M12 Motorway

Amendment Report

October 2020

Figure 3-7 Amended operational footprint

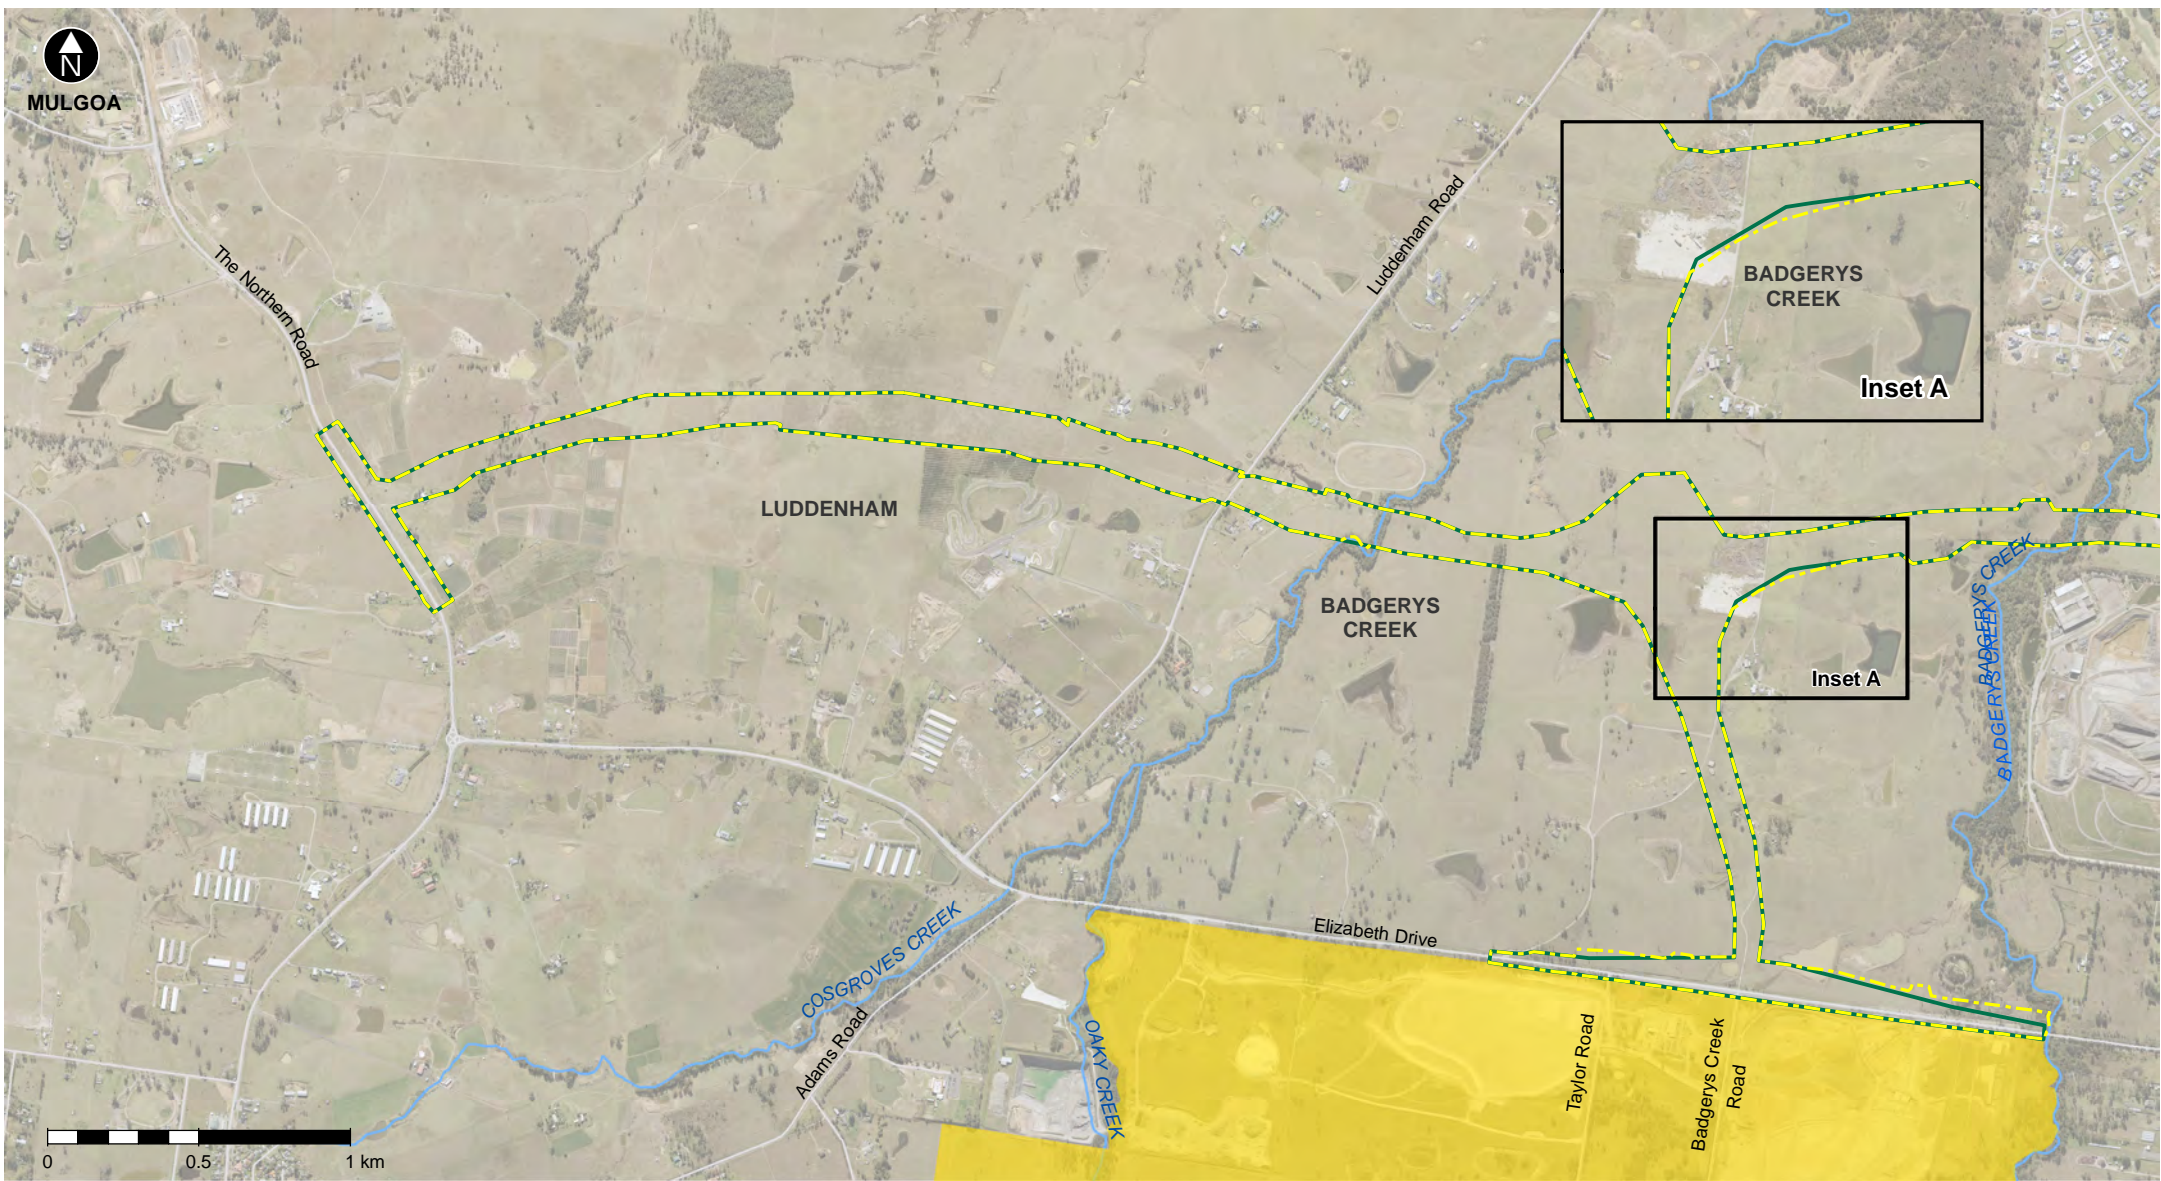
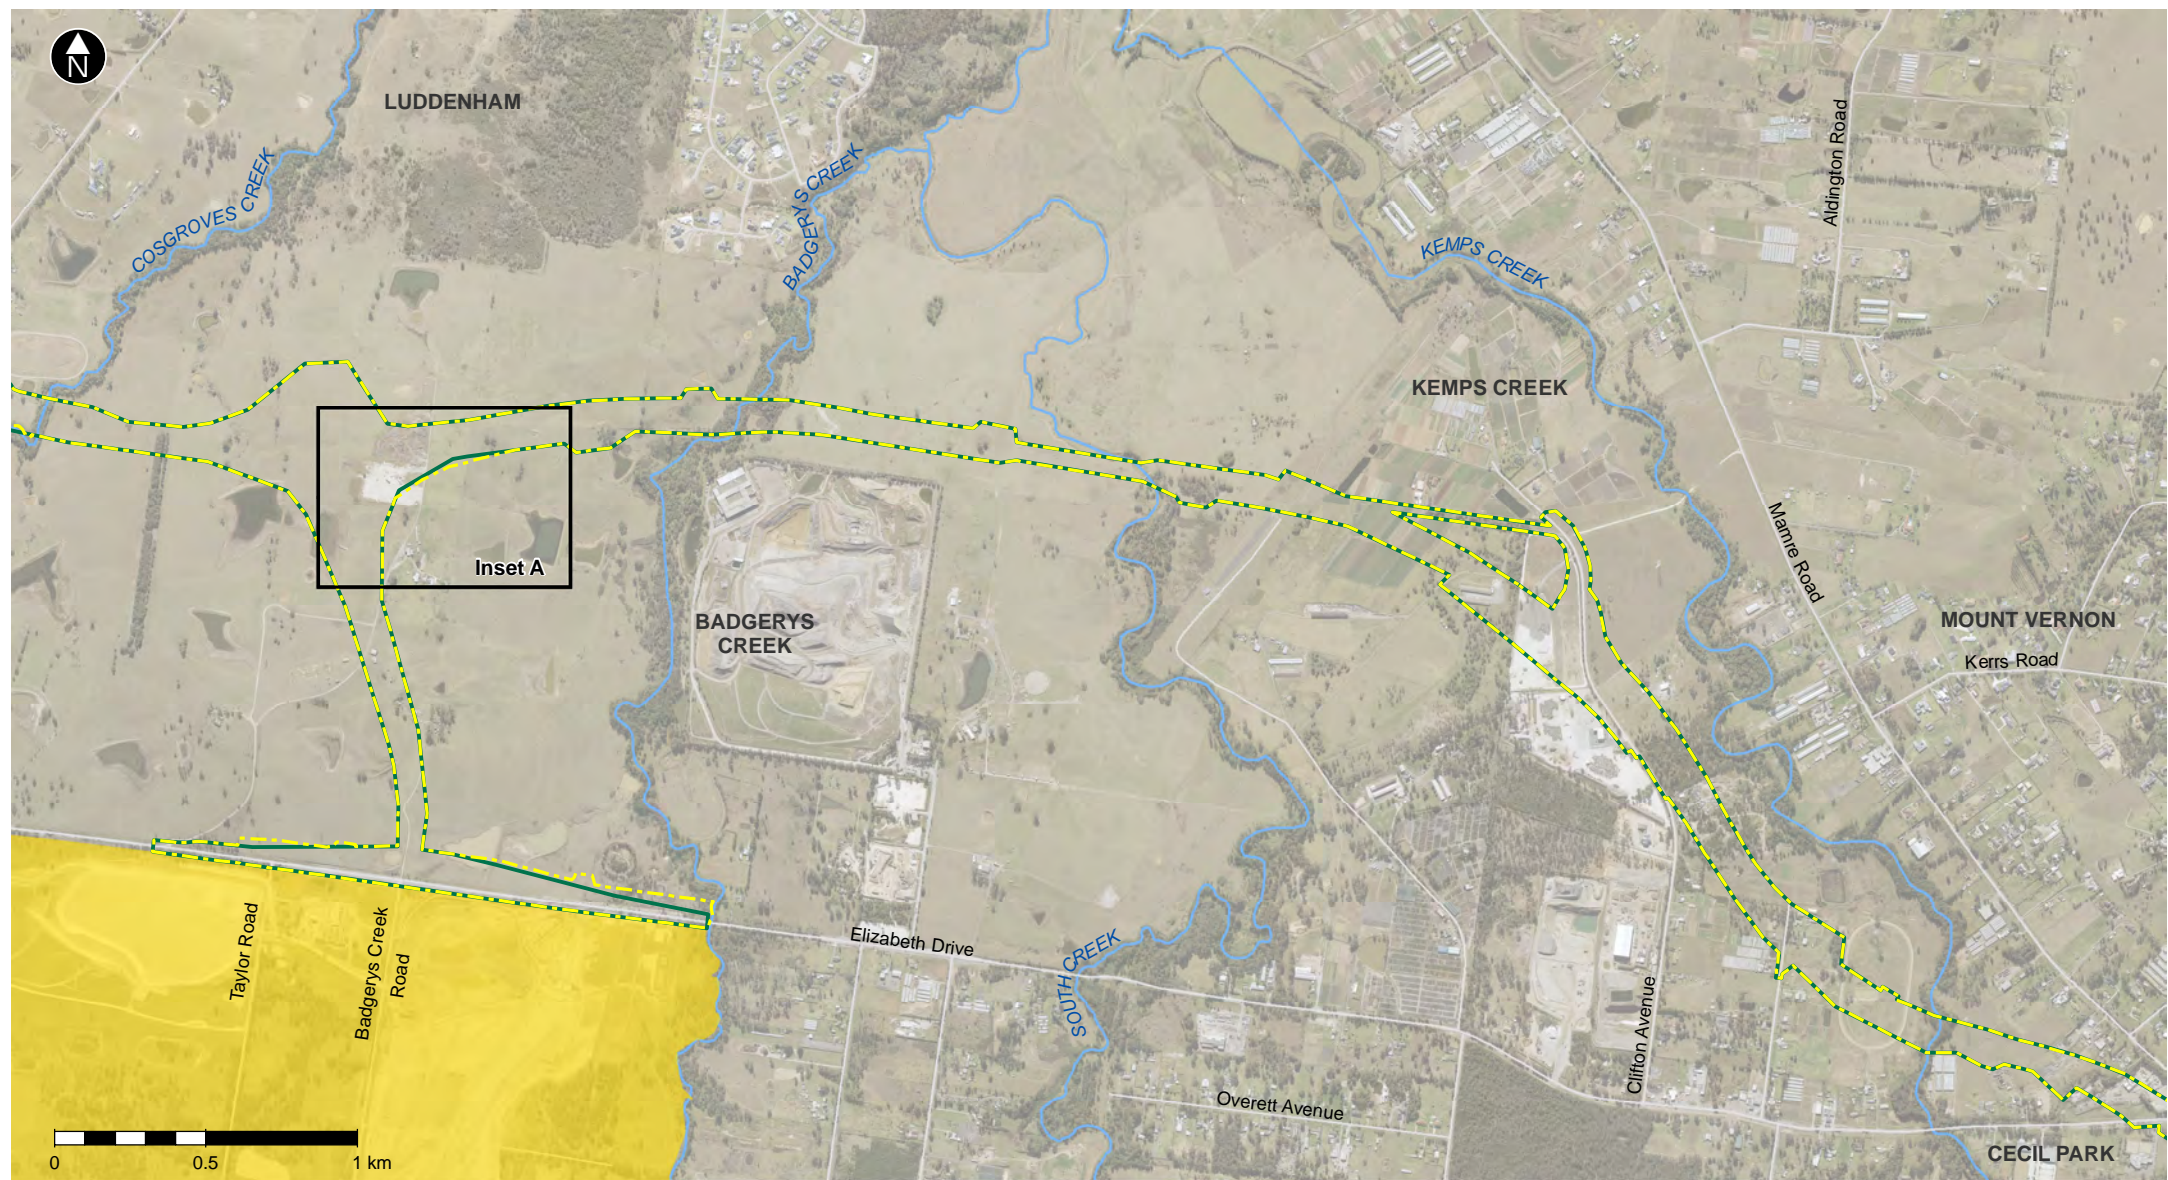
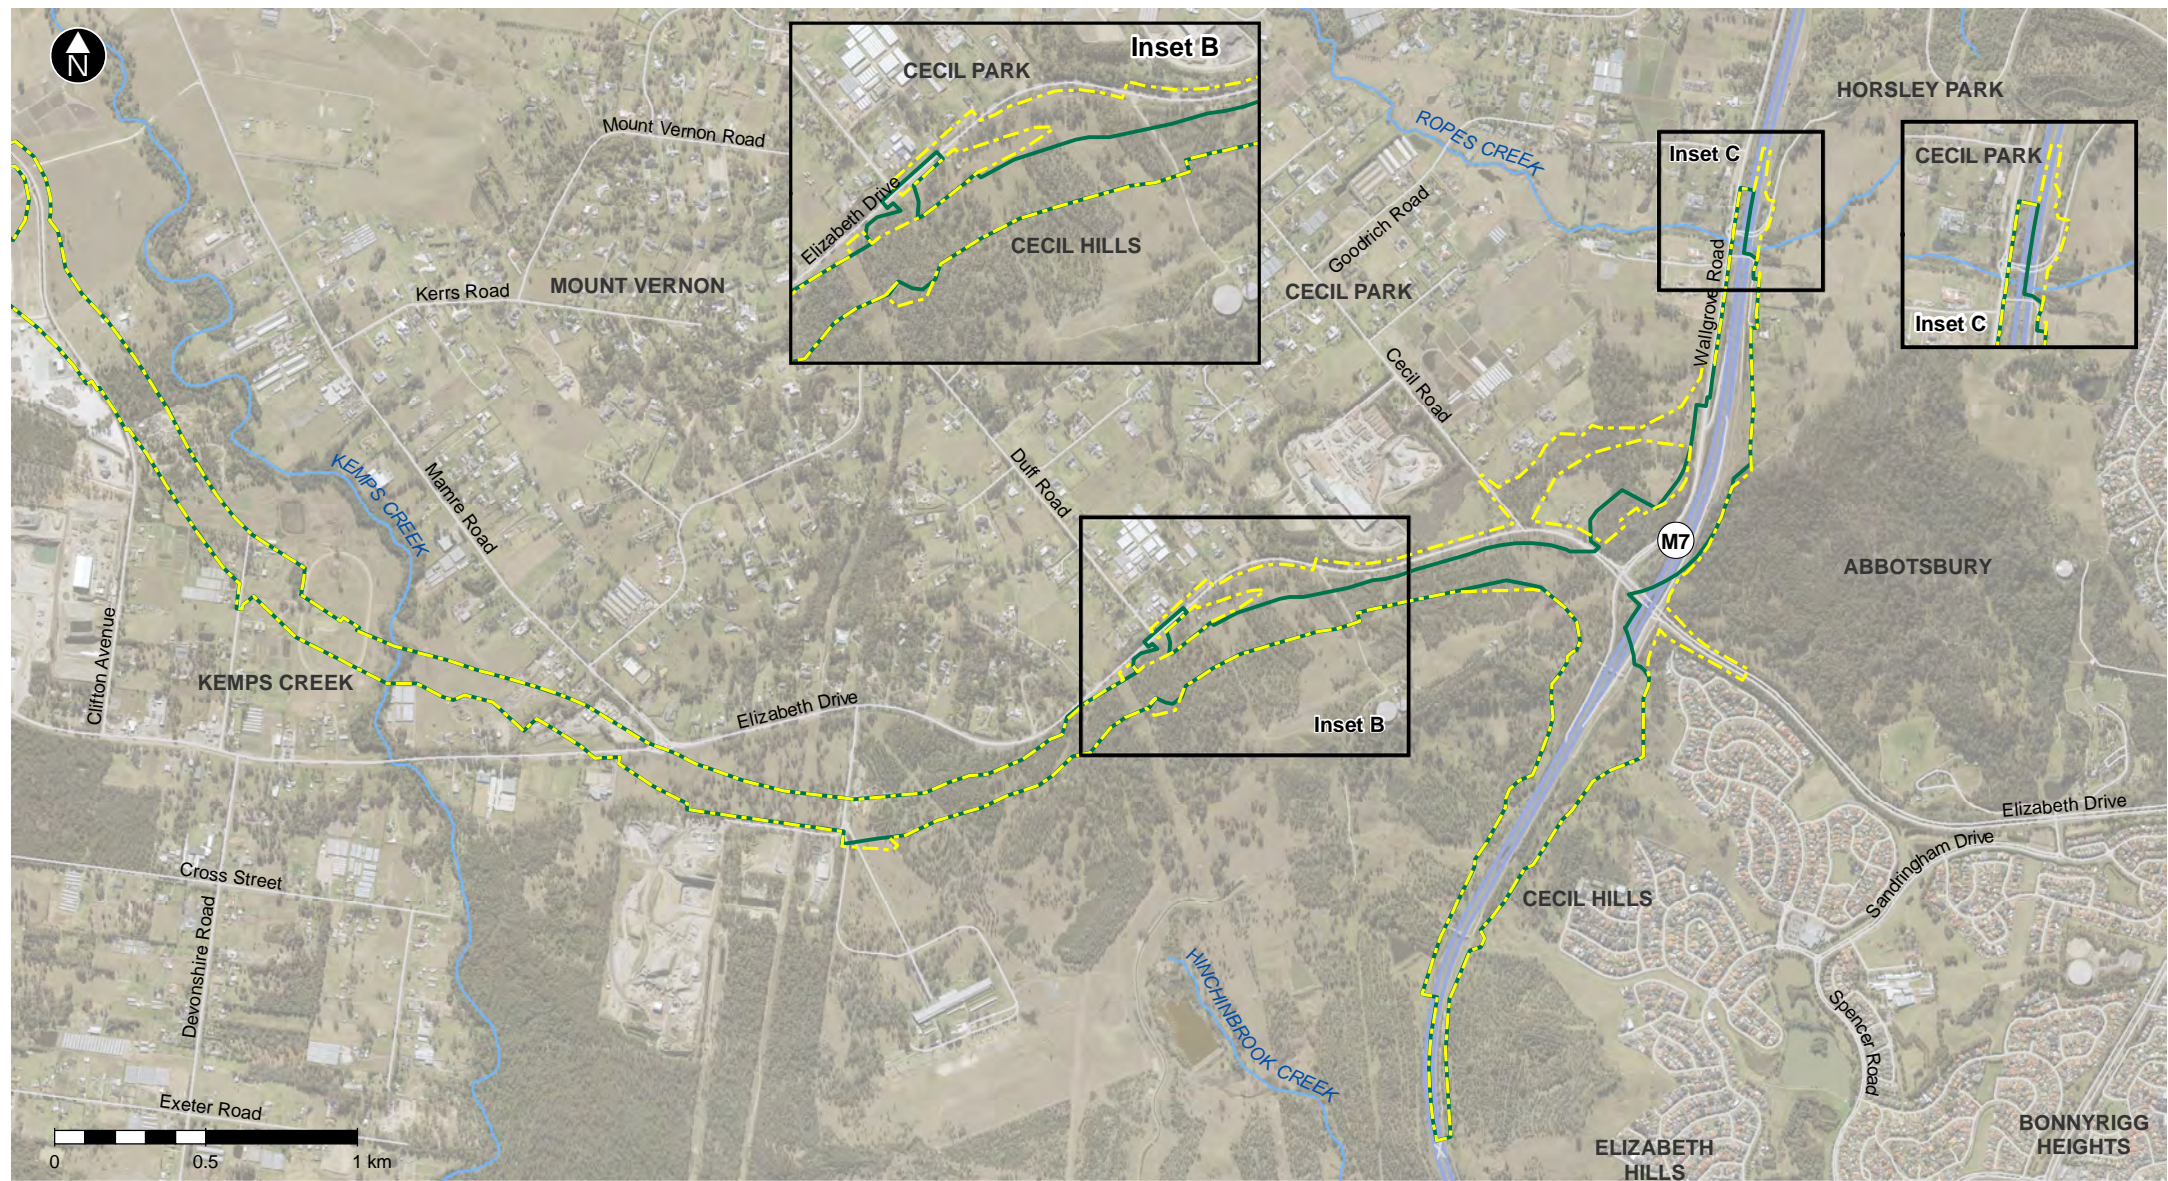
The operational footprint generally includes the M12 Motorway and additional areas required for operation and maintenance of the project. The operational footprint of the project as described in the EIS is shown in **Figure 3-7**, and would comprise about 285 hectares.

This updated footprint is referred to as the amended operational footprint and would comprise about 317 hectares. This is an increase of about 32 hectares. Both the amended operational footprint and the operational footprint as described in the EIS are shown in **Figure 3-7** for ease of comparison.
